COMPONENT CODE 15 **PARTS & SERVICE** REF NO. AT03217 DATE Nov. 14, 2003 ews Page 1 of 16 (C)

SUBJECT: OVER SIZE PLATE OF TRANSMISSION

PURPOSE: To introduce the over size plate to use when overhauling the transmission ass'y

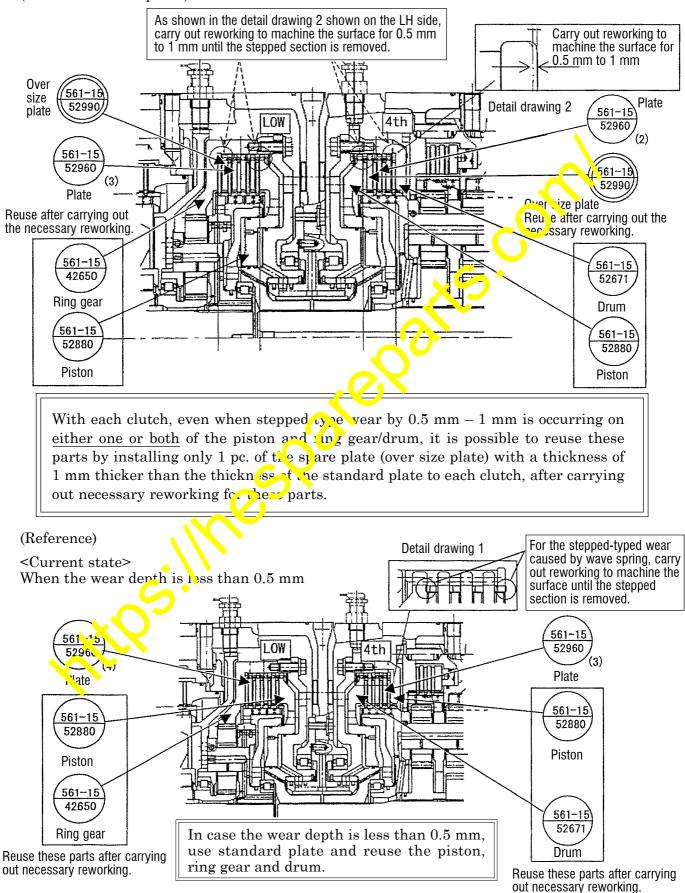
Even when the sliding surfaces of the piston, ring gear and drum for the clutches are worn by more than 0.5 mm, as seen in Fig. 1 shown below (In case of the HD785-3/-5, LOW clutch), it has become possible to reuse these parts by installing only 1 pc. of the spare plate with a thickness of 1 mm thicker than the standard thickness (over size plate) which have been developed this time.

Note) However, the ring gear, piston and drum with an abrasion extent exceeding 1 mm cannot be reused as above and it is necessary to replace those parts.

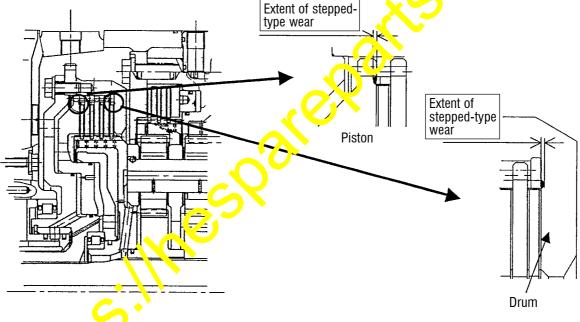
(1) In case the wear depth on the piston and on the ring gear/ drum is less than 0.5 mm each, it is possible to reuse these parts after carrying out necessary reworking for these parts as usual. Use the standard plate in this case.

Carry out reworking to machine the surface until the stepped section of less than 0.5 mm is removed.

- ② When the stepped-typed wear by 0.5 mm 1 mm is occurring on <u>either one or both</u> of the piston and ring gear/drum:
 - \rightarrow It is possible to reuse these parts after carrying out necessary reworking for these parts. However, it is necessary to install only 1 pc. of the over size relate to each clutch.
- (3) However, in case the wear depth of the piston and the ring gear/drum re exceeding 1 mm:
 - \rightarrow It is not allowed to reuse these parts. When the wear depth weeds 1 mm, it is necessary to replace these parts.

Fig. 2-1. Detailed reworking drawing for the ring gear, piston and drum

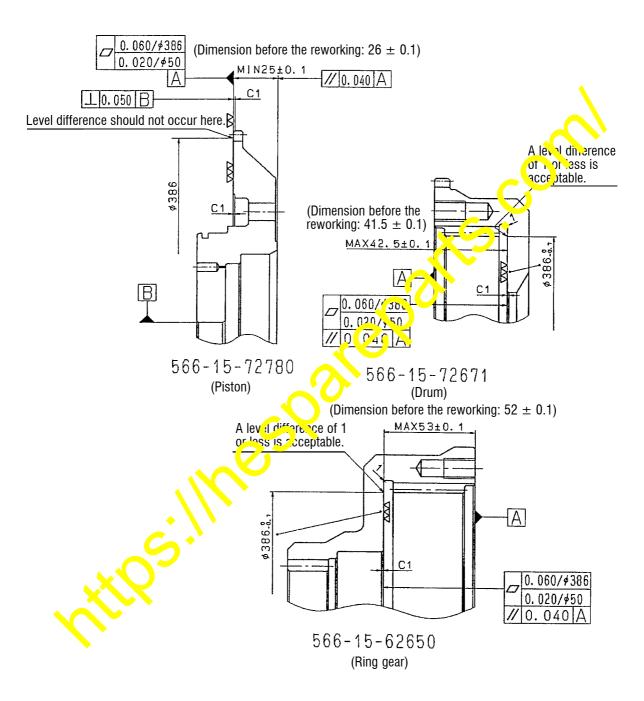
(1) As per the instructions given in Fig. 2-1 shown below, carry out reworking to machine the stepped-typed wear section on the piston (566-15-72780), ring gear (566-15-62650) and drum (566-15-72671) until the stepped-type wear sections will be removed.

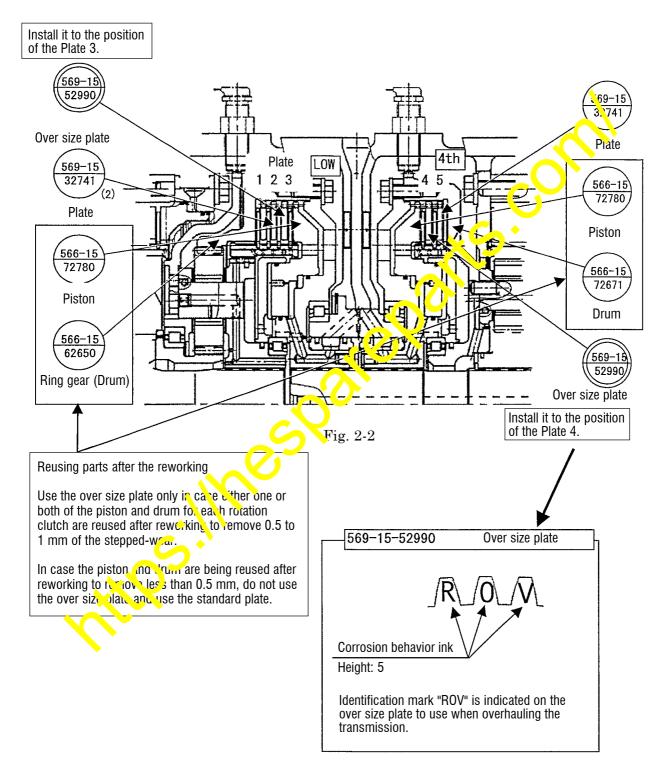
- (2) Reassembly procedure when overhauling
 - When carrying out the reassembly work, install the over size plate to the position instructed in Fig. 2-2 shown below.

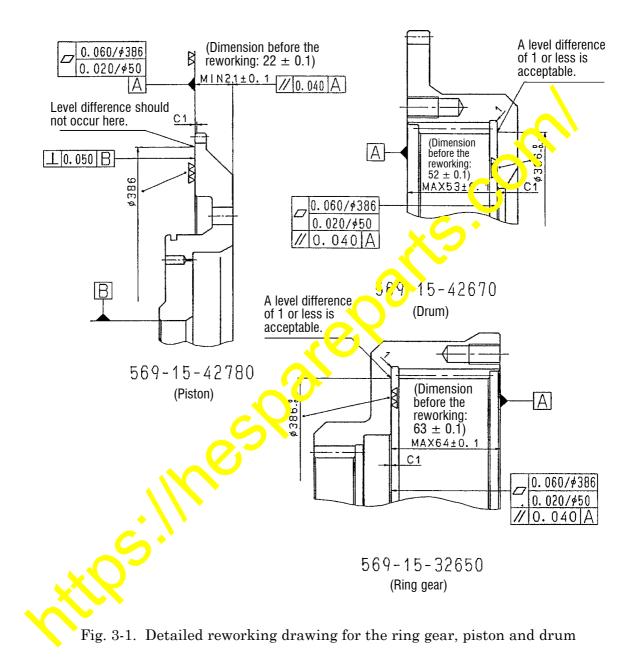
(1) As per the instructions given in Fig. 3-1 shown below, carry out reworking to machine the wave spring sliding surface on the piston (569-15-42780), ring gear (569-15-32650) and drum (569-15-42670) until the stepped-type wear sections are removed.

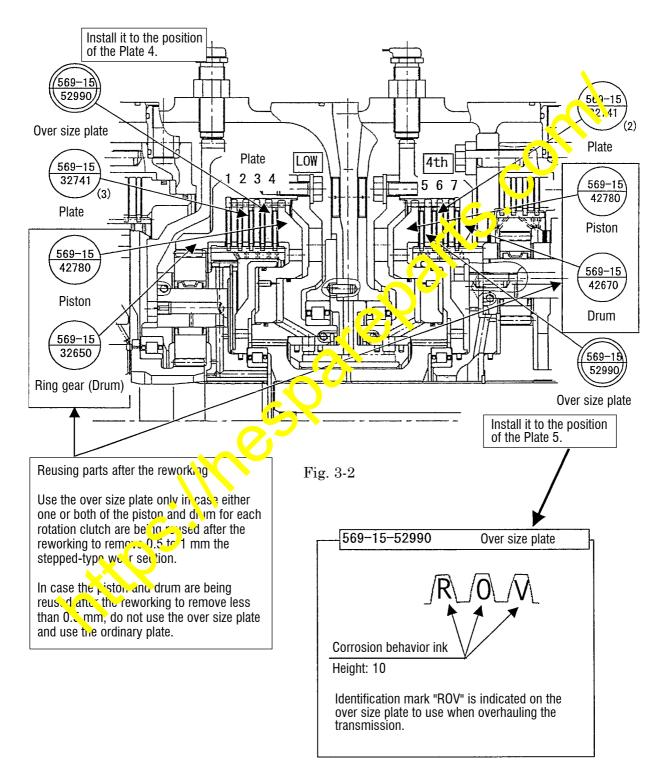
- (2) Reassembly procedure when overhauling
 - When carrying out the reassembly work, install the over size plate to the position instructed in Fig. 3-2 shown below.

Fig. 4-1. Detailed reworking drawing for the ring gear, piston and drum

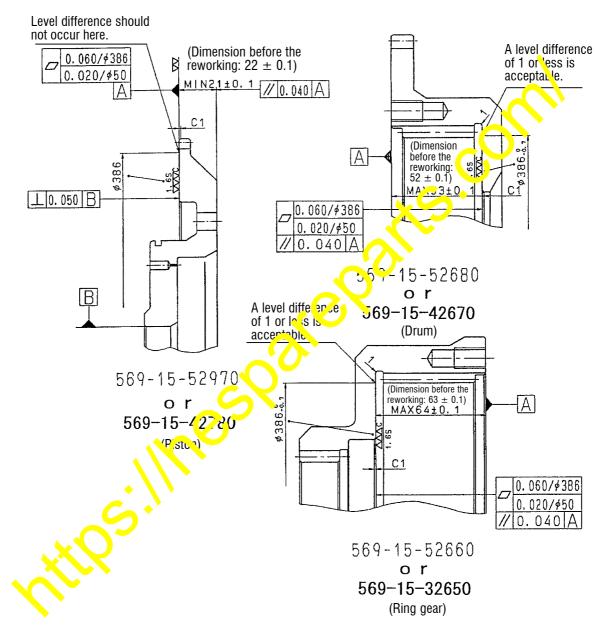
(1) As per the instructions given in Fig. 4-1 shown below, carry out reworking to machine the wave spring sliding surface on the piston (569-15-52970 or 569-15-42780), ring gear (569-15-52660 or 569-15-32650) and drum (569-15-52680 or 569-15-42670) until the stepped-typed wear is removed.

Note The machining traces of the section with the surface coarseness $\nabla \nabla \nabla$ (1.6S) should be in a concentric circle.

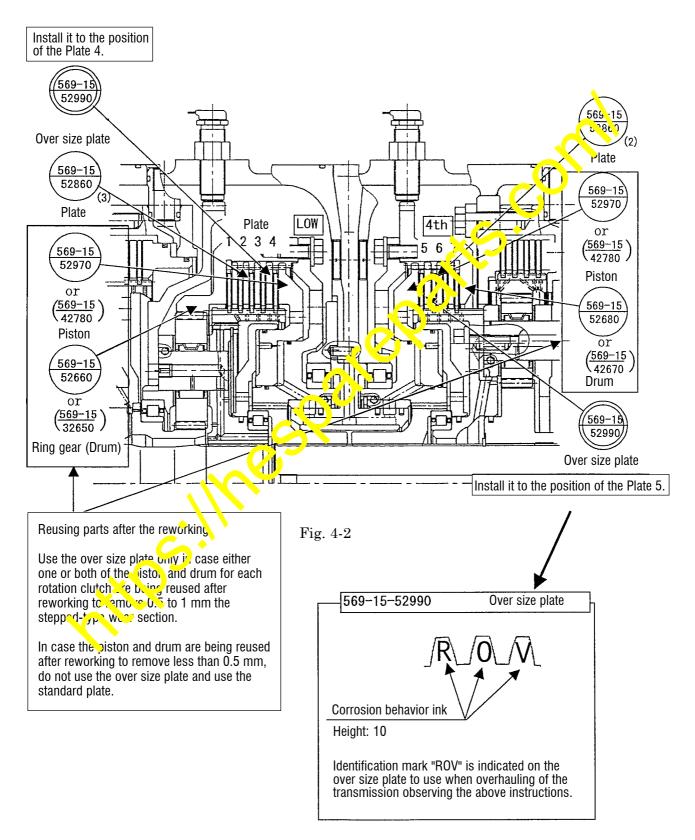
- (2) Reassembly procedure when overhauling
 - When carrying out the reassembly work, install the over size plate to the position instructed in Fig. 4-2 shown below.

Fig. 5-1. Detailed reworking drawing for the ring gear, piston and drum

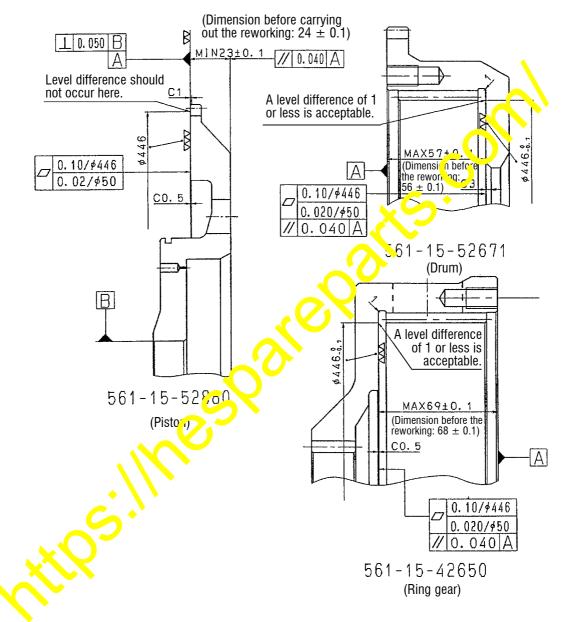
(1) As per the instructions given in Fig. 5-1 shown below, carry out reworking to machine the wave spring sliding surface on the piston (561-15-52880), ring gear (561-15-42650) and drum (561-15-52671) until the stepped-type wear sections will be removed.

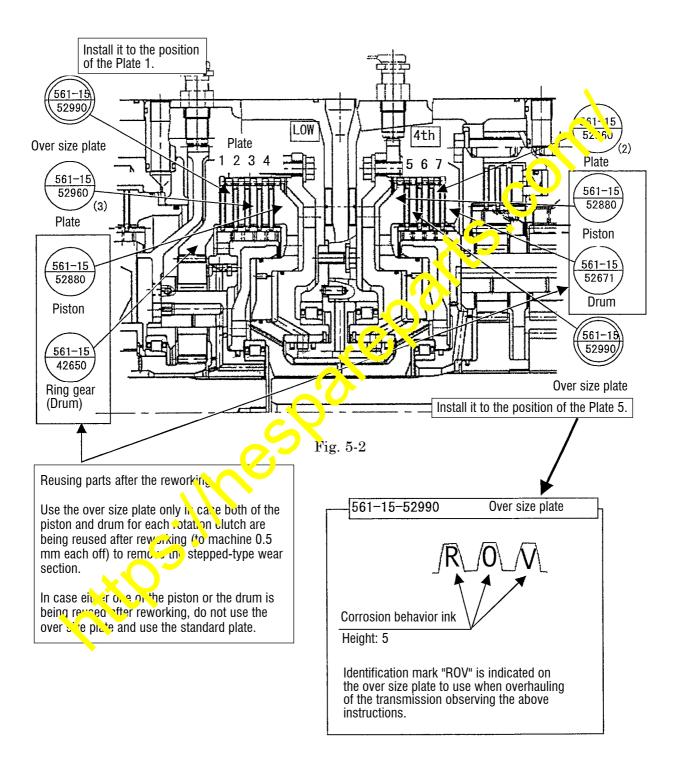
- (2) Reassembly procedure when overhauling
 - When carrying out the reassembly work, install the over size plate to the position instructed in Fig. 5-2 shown below.

Fig. 6-1. Detailed reworking drawing for the ring gear, piston and drum

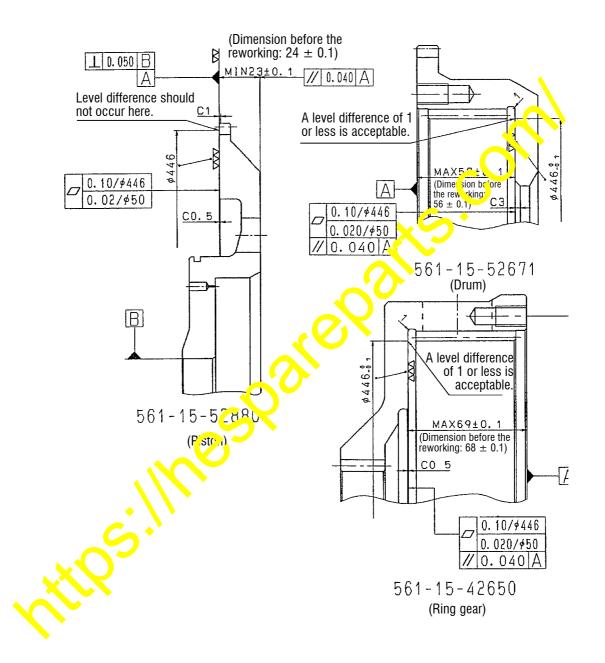
(1) As per the instructions given in Fig. 6-1 shown below, carry out reworking to machine the wave spring sliding surface on the piston (561-15-52880), ring gear (561-15-42650) and drum (561-15-52671) until the stepped-type wear sections will be removed.

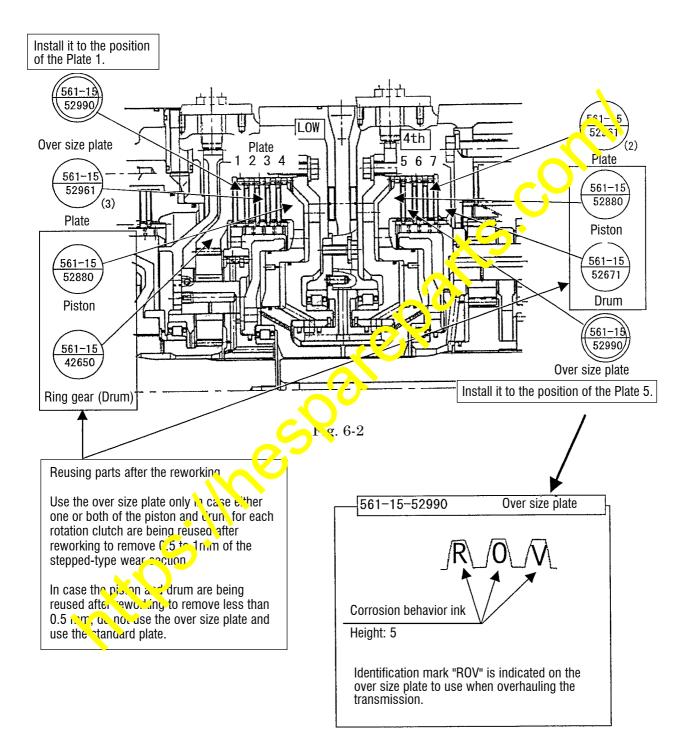
- (2) Reassembly procedure when overhauling
 - When carrying out the reassembly work, install the over size plate to the position instructed in Fig. 6-2 shown below.

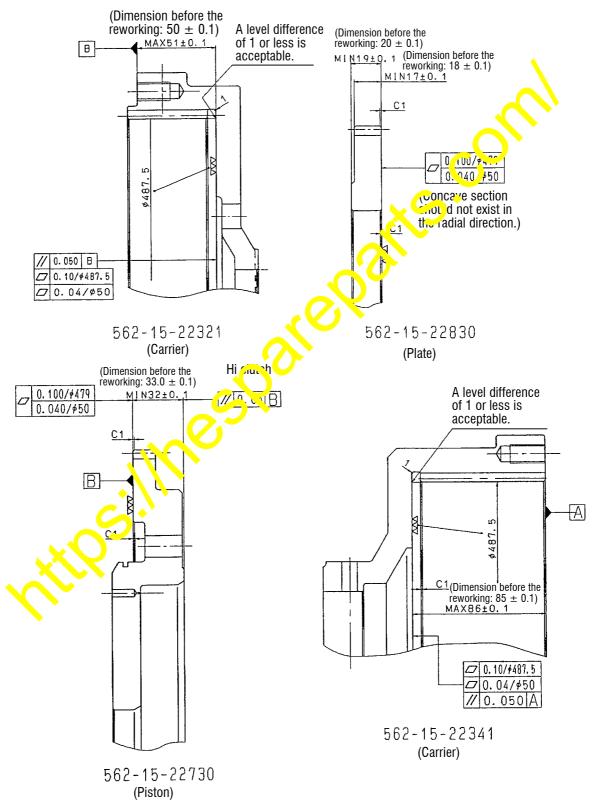
(1) As per the instructions given in Fig. 7-1 shown below, carry out reworking to machine the wave spring sliding surface on the carrier (562-15-22321 and 562-15-22341), piston (562-15-22730), plate (562-15-22830) until the stepped-type wear sections are removed.
